SAFETRAN
Systems Corporation
Electronic Division
10655 7TH STREET
Rancho Cucamonga, CA 91730

DWG NO.
A53470

EO/CN NO.
E024766

CHANGE NOTICE

DWG SHT 1

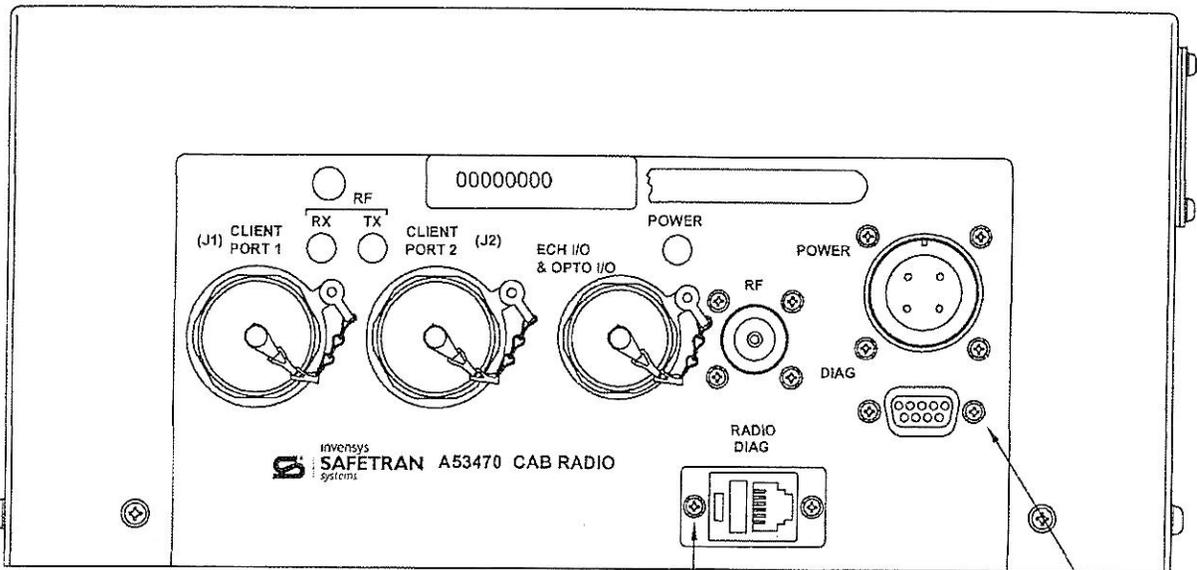
ZONE C8

IS 6-32 X .250 PAN HEAD

CI #6-32 x .375 SCREW, PAN HD

DWG SHT 1

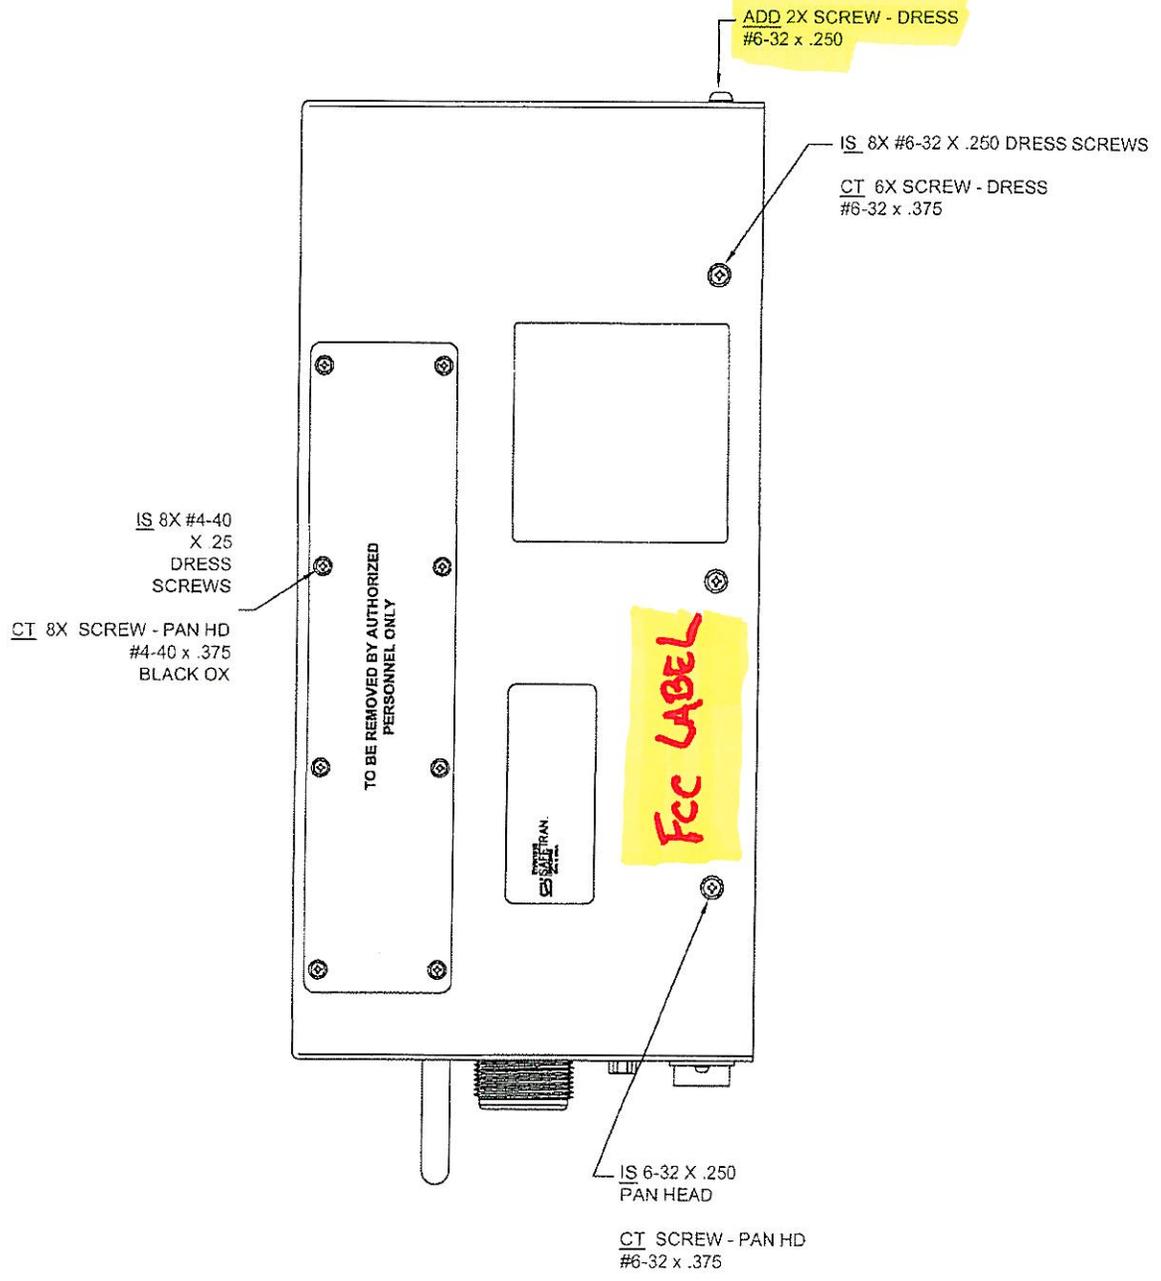
ZONES A6 - A8

ADD 2X #4-40 x .500 SCREW
PAN HD, BLK OX

ADD 2X #4-40 x .250 SCREW
PAN HD, BLK OX

DWG SHT 3

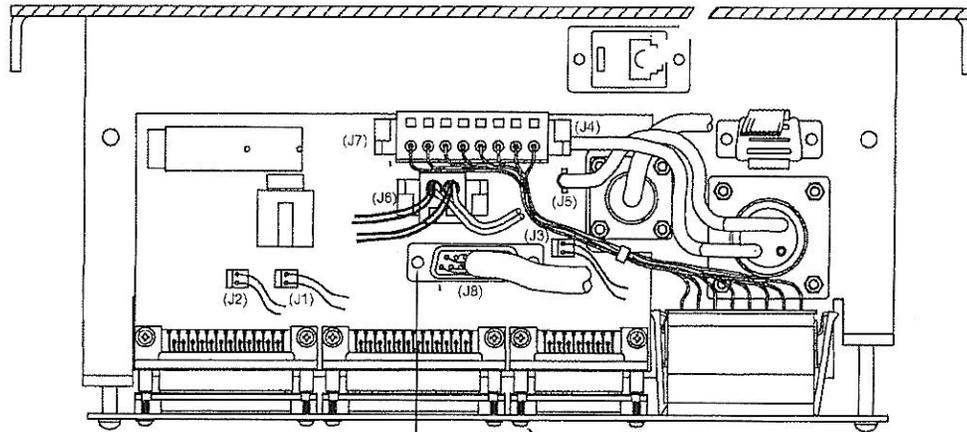
SECTION A-A

2X (42)

ADD

DETAIL A
POWER CORD
ASSEMBLY

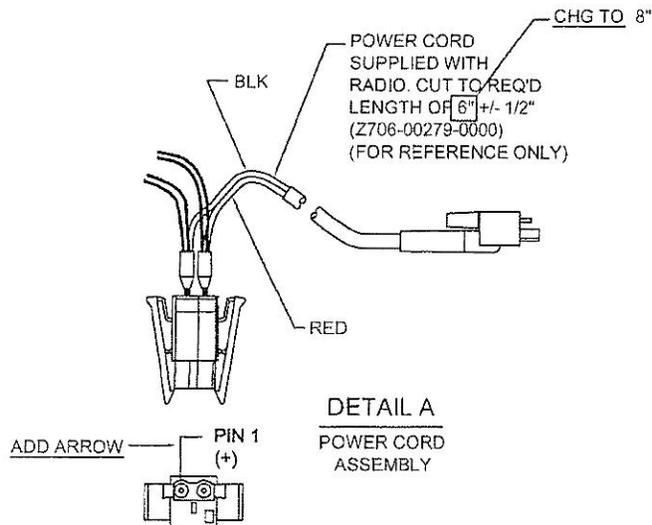
IS 6X #4-40 HDW X .25
CT 6X SCREW - PAN HD, #4-40 x .875
WSHR - FT, #4
WSHR - SPLIT LK, #4
